Russell Vale Colliery

PRELIMINARY RESIDUAL MATTERS REPORT

for
Wollongong Coal Limited
March 2014

RUSSELL VALE COLLIERY UNDERGROUND EXPANSION PROJECT

Figure 1: Plan of PPR mining area and previous mining activity.

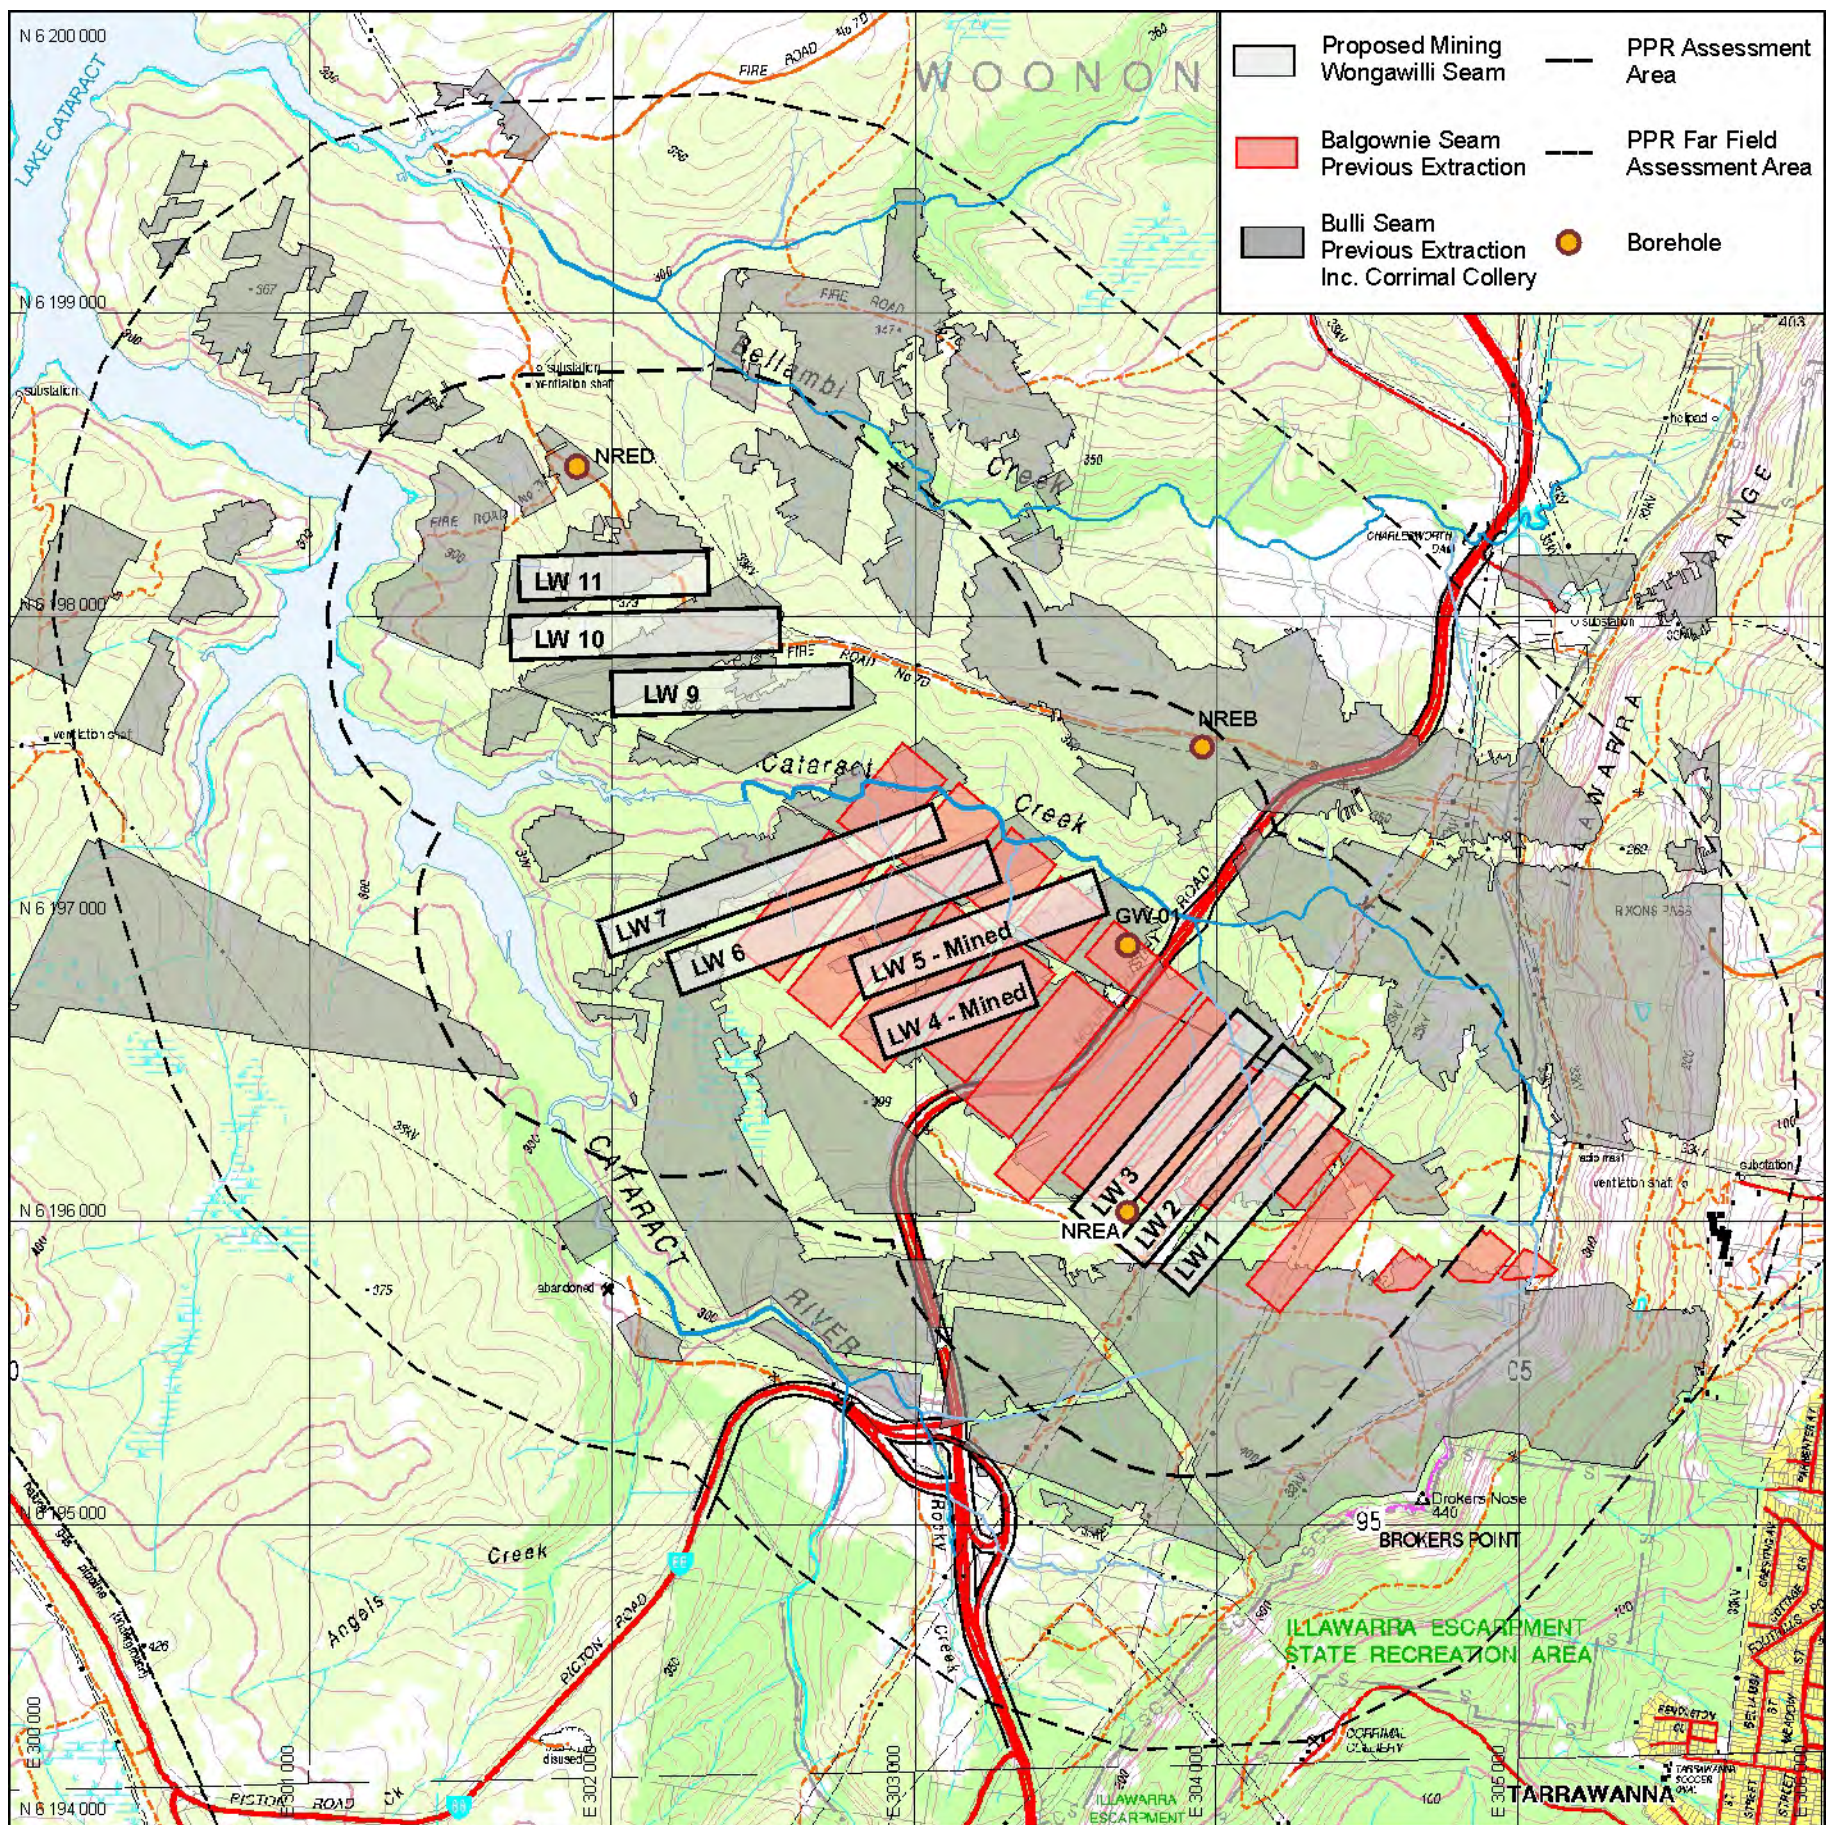
DP&I noted that no scale is shown on the mine plan figure of the UEP PPR and also that it is not geo-referenced. DP&I requires confirmation of the positioning of Cataract Creek with respect to LW7 of the PPR mine plan.

Ref	Regulator	Issue	Where Addressed
1.	DP&I	The new mine plan is presented in Figure 4 of the PPR however no scale is shown and it is not georeferenced. This mine plan was positioned with respect to the MGA by overlaying the EA and PPR mine plans of Figure 4 of the PPR onto a georeferenced drawing of the EA mine plan, and scaling it until a visual match was obtained between the two versions of the EA mine plan. The result is shown in Figure 1. This process allowed positioning of Cataract Creek (not shown in Figure 4 of the PPR) with respect to LW7 of the PPR mine plan. However, the positioning error from this process is unknown.	Figure 1

Figure 1 demonstrates scale, geo-referencing and the relative positioning of Cataract Creek.
